City of Greenville, Ohio
WWTP Solids Handling Facility and Administration Building

ADDENDUM 3

1.16.2025

**BLOWERS
 P & ID**
 CITY OF GREENVILLE, OHIO
 WWTP SOLIDS HANDLING FACILITY AND ADMINISTRATION BUILDING

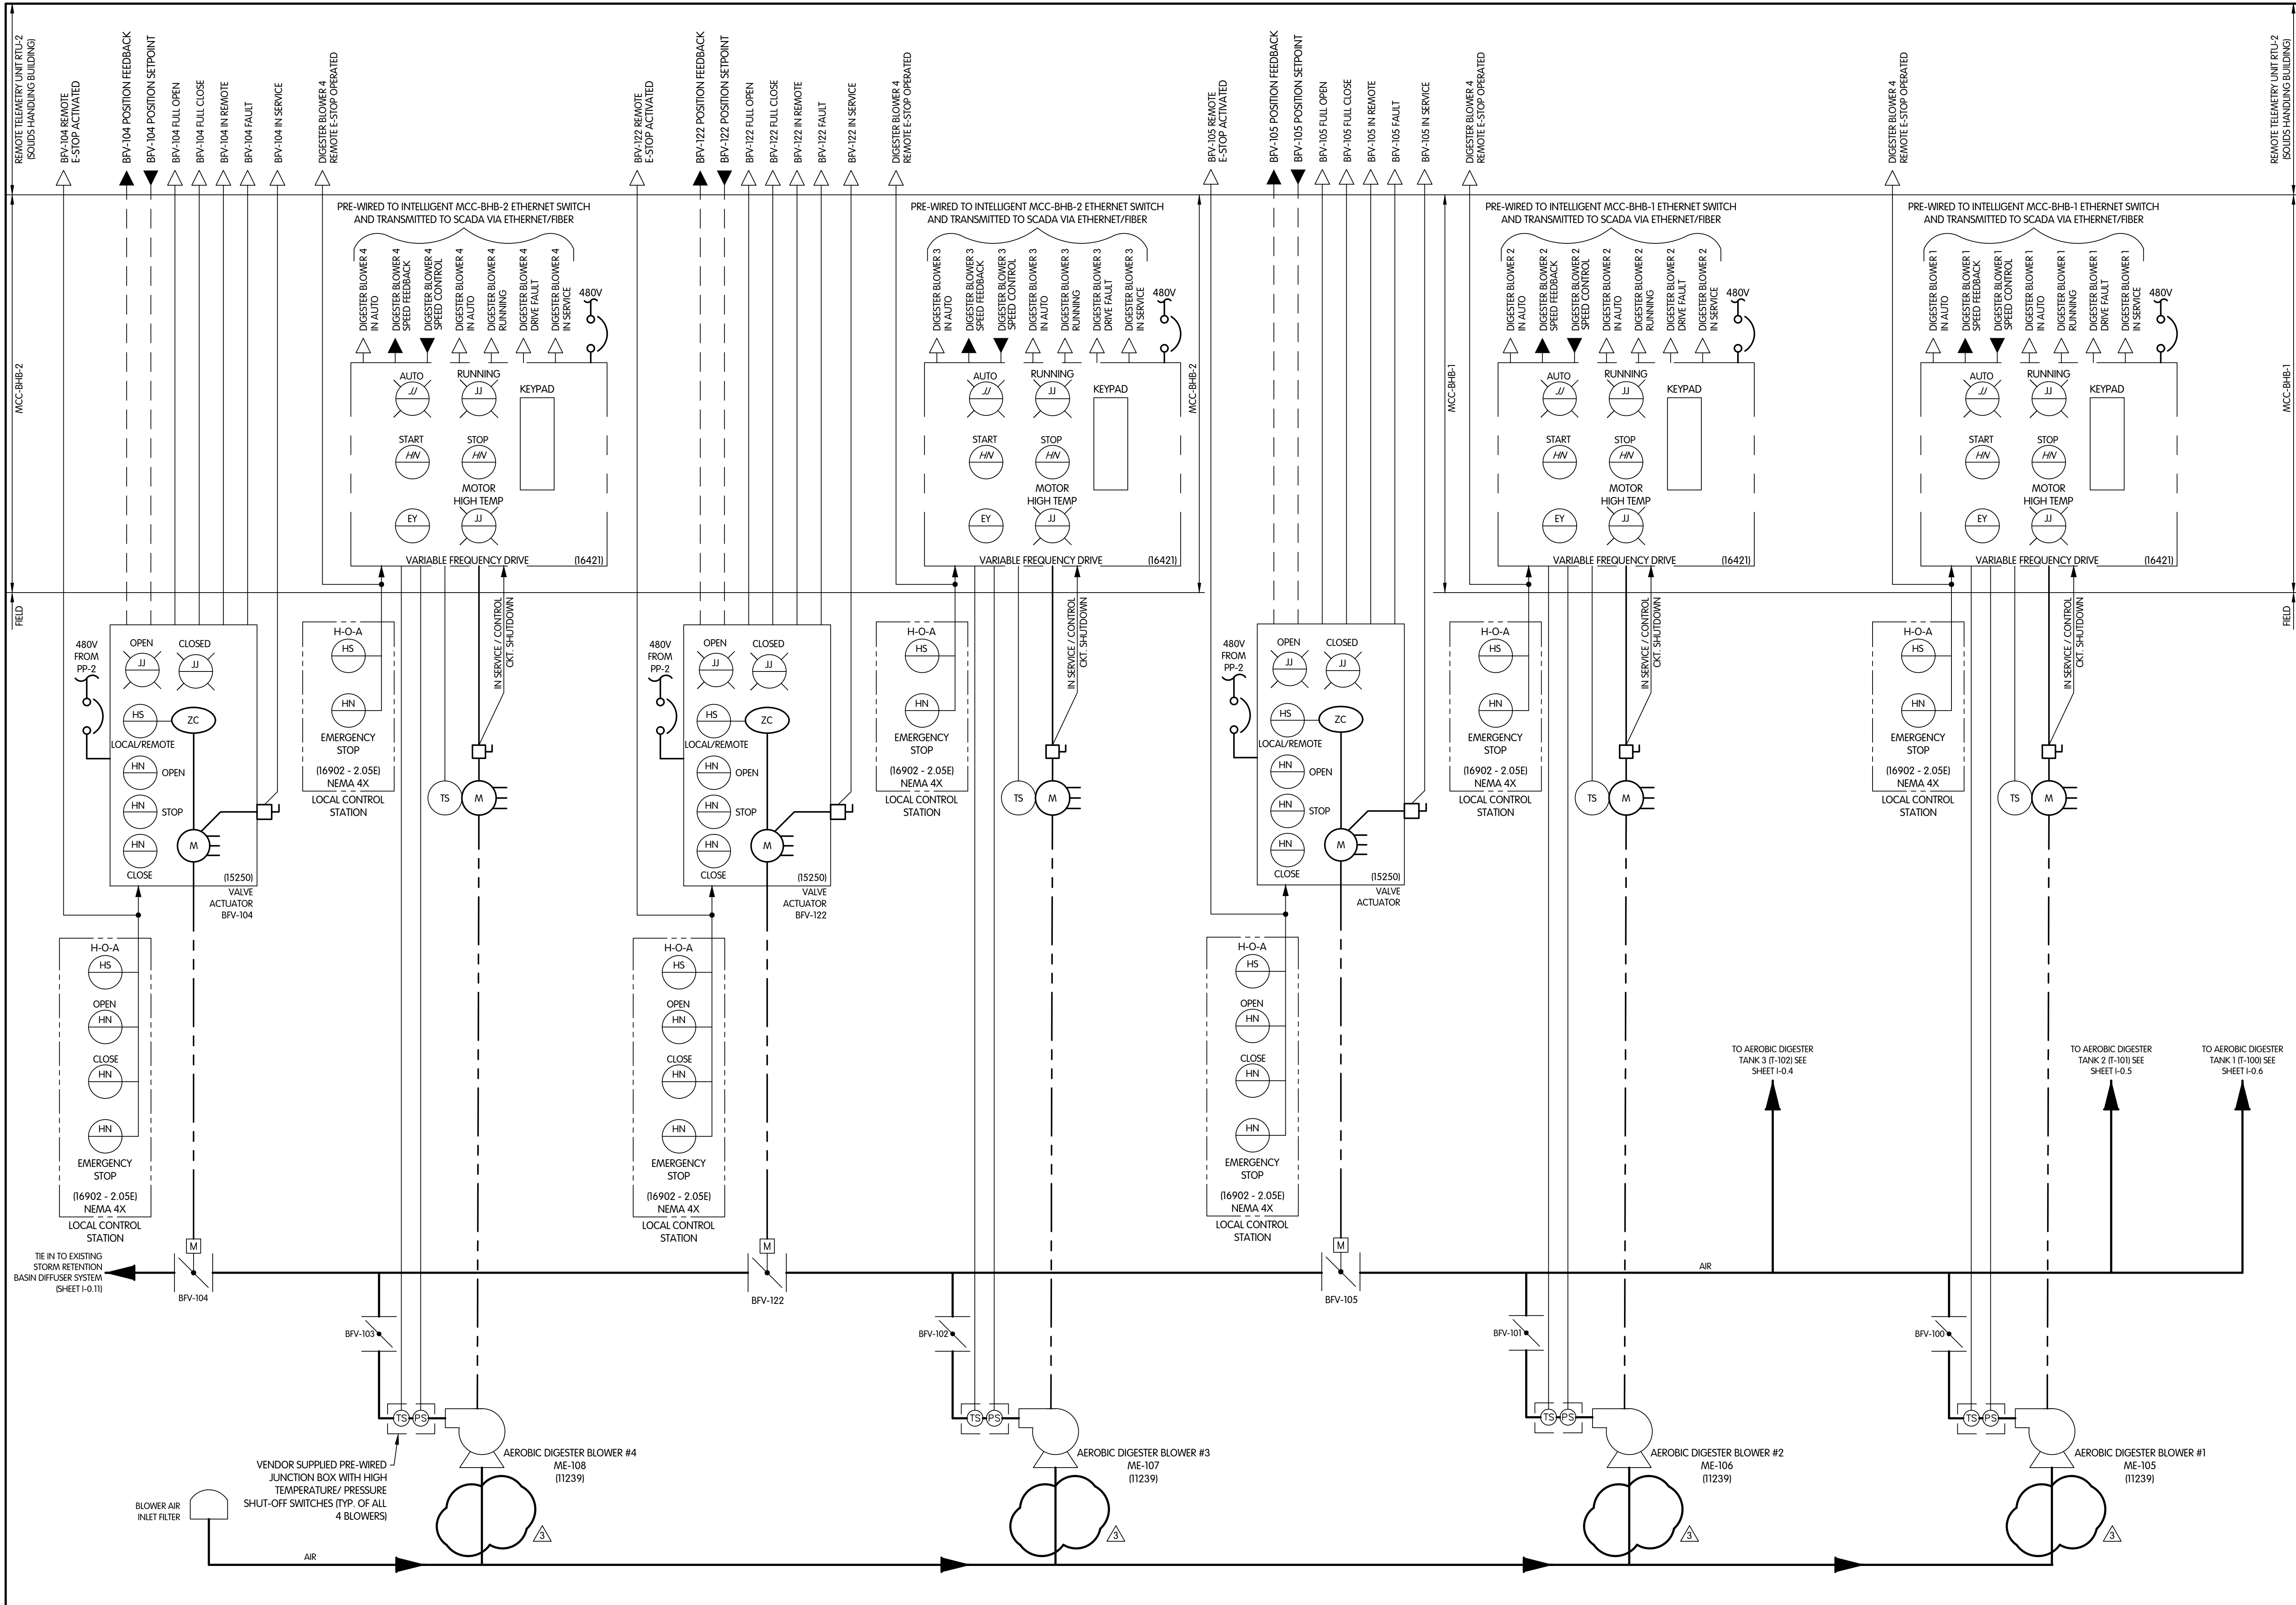
Question: Drawing P1.3 Section 3 shows BFV 123 on the suction side of the blower. We don't recommend butterflies on the suction side. If someone accidentally closes it the blower will collapse the silencer and possibly damage the blower.

Response: *Inlet isolation valves for each blower have been removed. Refer to updated sheets - PE 0.1, PE 1.3, PE 2.3, PE 2.4, G 0.5, and I 0.7 included in Addendum 3.*
